Schematic	SI5351_TCXO_WithMixerAndFilters	Create at	2026-04-02
		Update at	2026-04-03
Board	SI5351_TCXO_WithMixerAndFilters	Page	PSU
Drawn		SCH_SI5351_TCXO_WithMixerAndFilters_Version2	
Reviewed			
		Version	Size	Page 1 Total 11
EasyEDA		V1.0	A4	EasyEDA.com

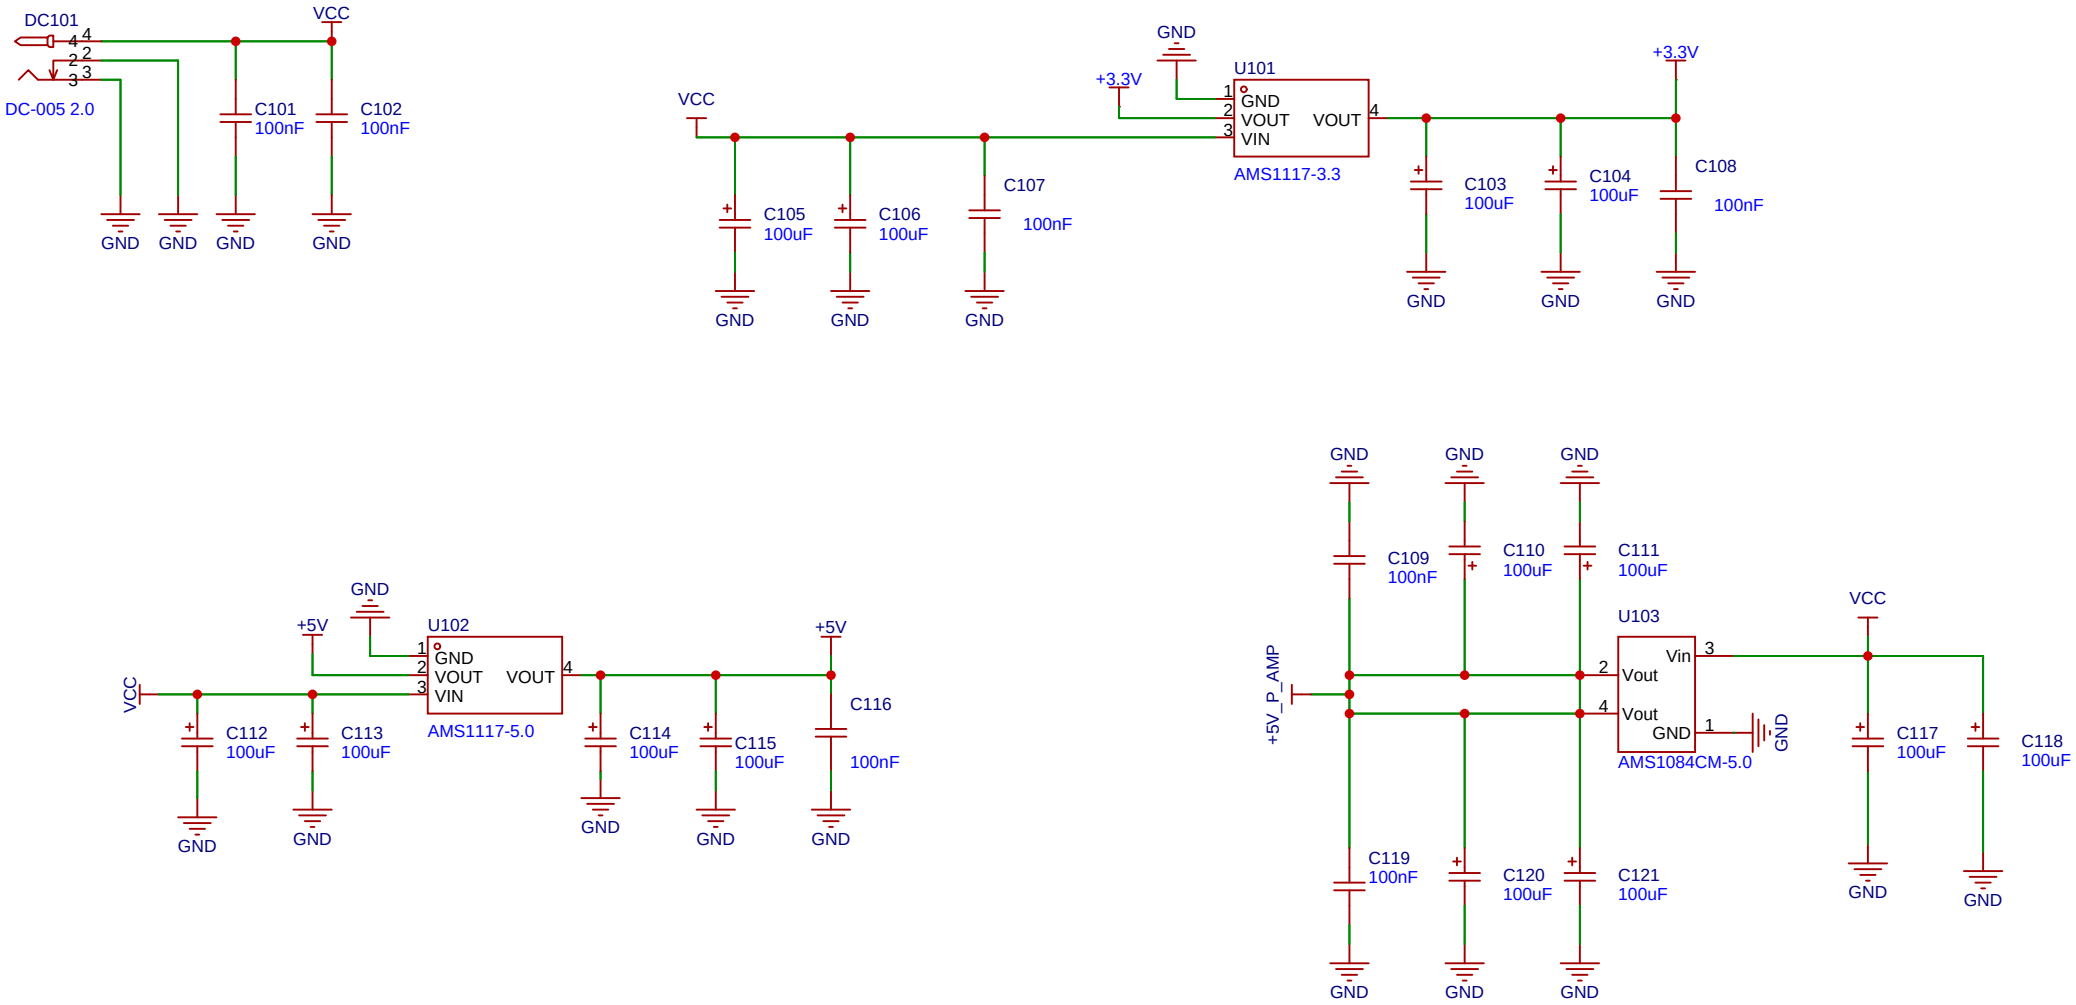
Alle komponenter svarer til LCSC Part numre fra sidste ordre

Layout is made for 1XTW6000MAA (DSB321SDN) TCXO

Det skal kontrolleres om kredsløbet svarer til Theonethatiwant, clockosc gør, men hvad med resten?

Komponenter svarer til oprindeligt schematic.

Skal decoupling fortsætte som den er nu? Eller simplificeres?

Schematic	SI5351_TCXO_WithMixerAndFilters	Create at	2026-04-02
		Update at	2026-04-03
Board	SI5351_TCXO_WithMixerAndFilters	Page	SI5351_TCXO
Drawn		SCH_SI5351_TCXO_WithMixerAndFilters_Version2	
Reviewed			
		Version	Size	Page 2 Total 11
EasyEDA		V1.0	A4	EasyEDA.com

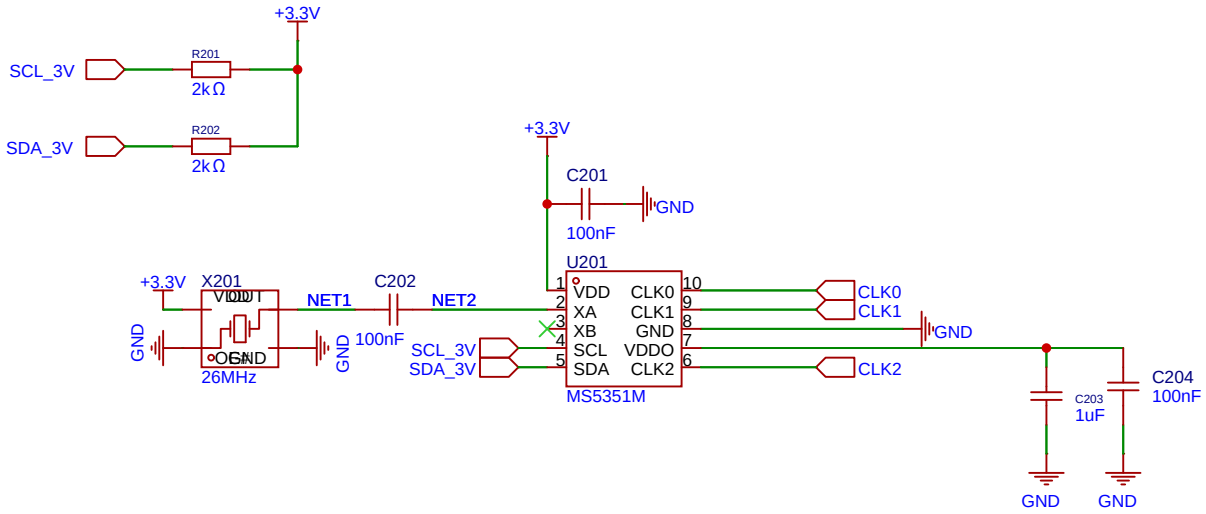
Det skal kontrolleres om kredsløbet svarer til Theonethatiwant, clockosc gør, men hvad med resten?

Schematic	SI5351_TCXO_WithMixerAndFilters	Create at	2026-04-02
		Update at	2026-04-03
Board	SI5351_TCXO_WithMixerAndFilters	Page	RF_FILTER
Drawn		SCH_SI5351_TCXO_WithMixerAndFilters_Version2	
Reviewed			
		Version	Size	Page 3 Total 11
EasyEDA		V1.0	A4	EasyEDA.com

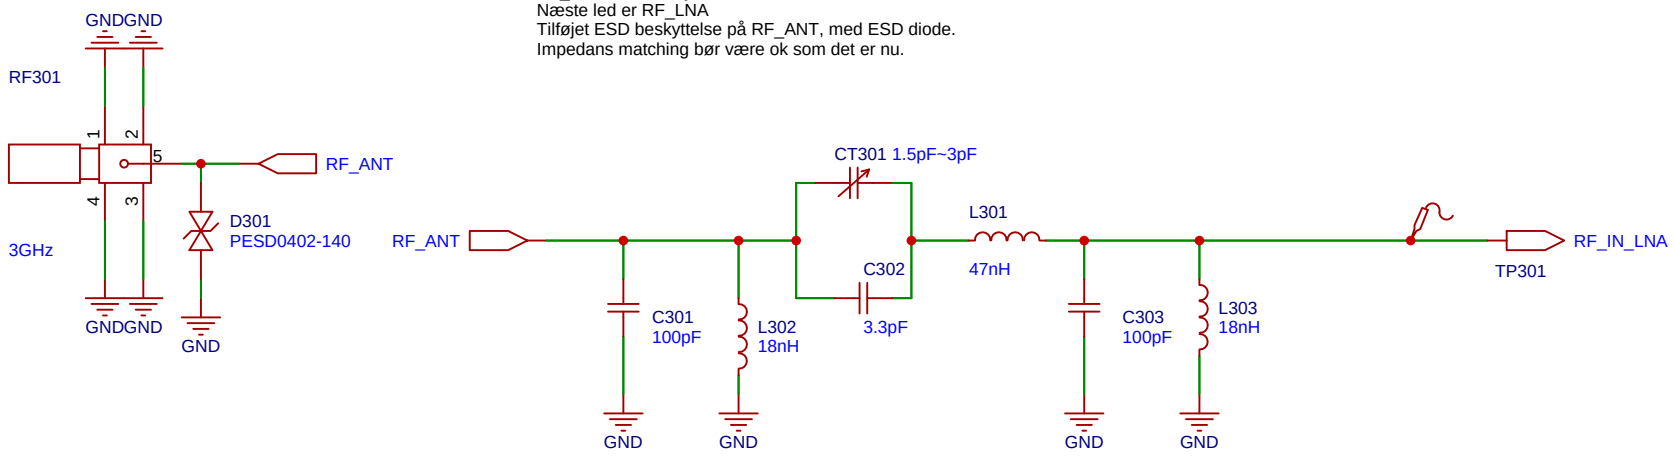
RF_Filter er blevet justeret sammen med Claude.
Næste led er RF_LNA
Tilføjet ESD beskyttelse på RF_ANT, med ESD diode.
Impedans matching bør være ok som det er nu.

Schematic	SI5351_TCXO_WithMixerAndFilters	Create at	2026-04-02
		Update at	2026-04-03
Board	SI5351_TCXO_WithMixerAndFilters	Page	IF1_FILTER
Drawn		SCH_SI5351_TCXO_WithMixerAndFilters_Version2	
Reviewed			
		Version	Size	Page 6 Total 11
EasyEDA		V1.0	A4	EasyEDA.com

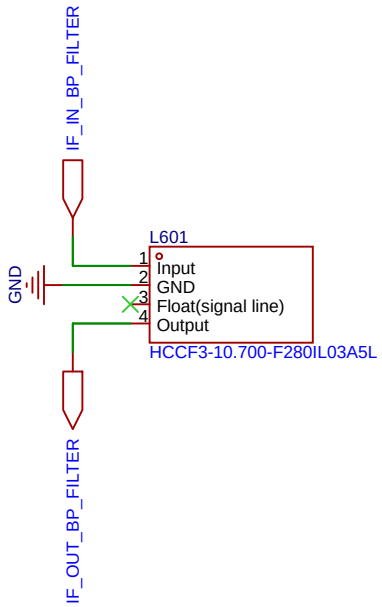
IF_Filter 1 Skal være 10.7MHz

Dette filter har umiddelbart 330ohm input og output impedance?
